REMARKS

Appl. No. 10/089,351
Atty. Docket No. 8278
Amdt. dated September 25, 2003
Reply to Final Office Action dated July 28, 2003
Customer No. 27752

Fig. 58

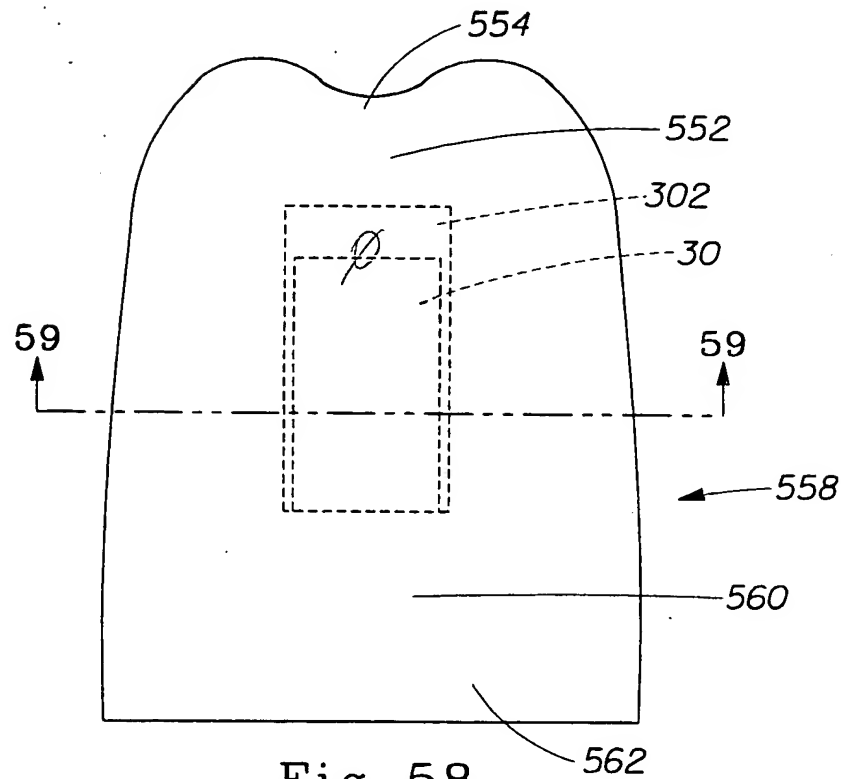
The Examiner has disapproved the proposed substitute sheets of drawings filed May 22, 2003. In particular, the Examiner stated that an incomplete set of drawings was received. Applicants herein are submitting a complete set of drawings detailing all figures originally presented in this case. Additionally, Applicants are submitting changes consistent with 37 C.F.R. §1.83. In particular, Fig. 51 is bracketed to indicate a single entity, and the second dotted box presented in Fig. 58 has been removed.
